Economic Commission for Europe**Inland Transport Committee****Working Party on Customs Questions affecting Transport****Group of Experts on Conceptual and
Technical Aspects of Computerization of the TIR Procedure****First session**

**eTIR conceptual, functional and technical specifications version 4.3:
Amendments****Amendments - Suspension of an eTIR intermodal transport,
procedure for drawing samples, messages exchanged in the
framework of the eTIR specifications and replication of
ITDB****Note by the secretariat****I. Introduction - Mandate**

Figure I

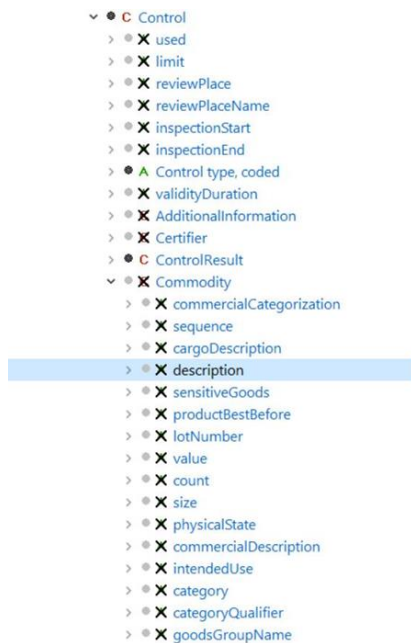
16. Alternatively, both the “Start TIR operation” (I9) and “Terminate TIR operation” (I11) messages contain a “Controls” class which currently serves for indicating the results of the checks of the seals. Consequently, the cardinality of this class is limited to 1. However, by increasing the cardinality, including a new control type for the drawing of samples and including a few additional attributes in the class, this class could serve to report on the drawing of samples.

17. The figure below shows the composition of the control class in the WCO data model, including the composition of the included commodity class.

18. The commodity class appears to have the necessary fields to indicate the amount of the sample drawn as well as the type of goods that was sampled.

Figure II
Replication schema

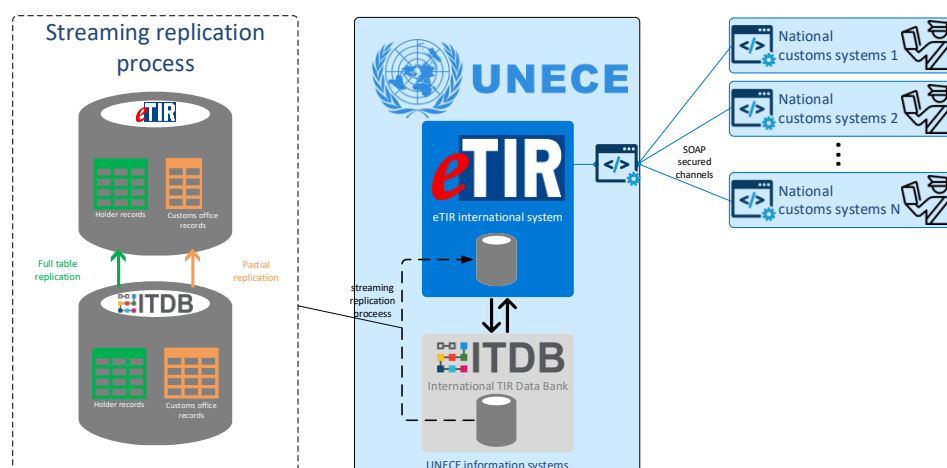
38. Beyond the initial database table copy, the replication could rely on real-time replication mechanism (also referred to as "streaming replication") to copy any update records of the database table, which contain the relevant TIR Carnet holder and customs offices data, from the ITDB to the eTIR international system. This mechanism shall ensure that the database replica of the ITDB hosted in the eTIR international database to be as current as possible. The Figure II provides a visual representation of the replication mechanism.

39. The data replication method will be “incremental”, i.e. only the differences between the original database and the replica will be applied. Such a process relies on the continuous communication of the Write-Ahead Logging (WAL) logs to both the master database (ITDB) and the replica one (eTIR international system local ITDB replica). However, the asynchronous replication approach will be preferred in order to minimize impact on ITDB database performance upon each commit. This method will reduce the amount of data to be exchanged and ensure the least burden on both systems.
